Access Compliance Report Public Rights-of-Way (Curb Ramps)

Main Street: JACKSON_ST Cross Street: ROOSEVELT_AVE Location: SW

ADA ID: RPRK211001144540 Ramp Type: Type 1 - Perpendicular Diagonal Initial Pass/Fail: Fail Overall Compliance: No Severity Score: 19

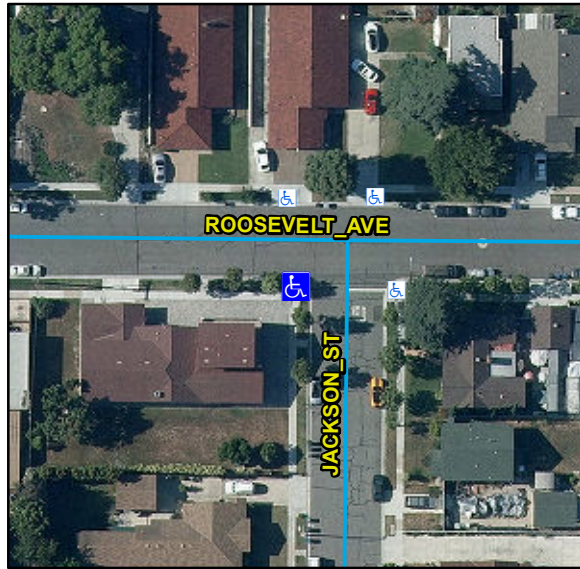
Compliance	Description	Data	Compliance	Description	Data
N/A	Ramp Length (in)	120	N/A	Flare Type LT	
No	Ramp Width (in)	47			N/A
No	Ramp Run Slope (%)	10.1	N/A	Flare Slope LT (%)	N/A
Yes	Ramp Cross Slope (%)	1.3	N/A	Flare Traversable LT	N/A
N/A	Landing Present	N/A	N/A	Flare Type RT	
N/A	Landing Length (in)	N/A			N/A
N/A	Landing Width (in)	N/A	N/A	Flare Slope RT (%)	N/A
N/A	Landing Run Slope (%)	N/A	N/A	Flare Traversable RT	N/A
N/A	Landing Cross Slope (%)	N/A	N/A	DWS Provided	N/A
N/A	Landing Movement Obstructed?	N/A	N/A	DWS Contrast	N/A
	Landing Movement Type	N/A	N/A	DWS Length (in)	N/A
N/A	Landing Shared	N/A	N/A	DWS Full Width	N/A
N/A	Clear Space	Yes	N/A	DWS Offset Left (in)	N/A
N/A	Clear Space To Crosswalk (in)	N/A	N/A	DWS Offset Right (in)	N/A
N/A	Marked Crosswalk 1	No	N/A	Marked Crosswalk 2	No
	Crossing 1 Direction	E		Crossing 2 Direction	N
	Marked Crosswalk 1 Width (in)	N/A		Marked Crosswalk 2 Width (in)	N/A

Remove & Replace Curb Ramp With Two New Directional Ramps or Equivalent.
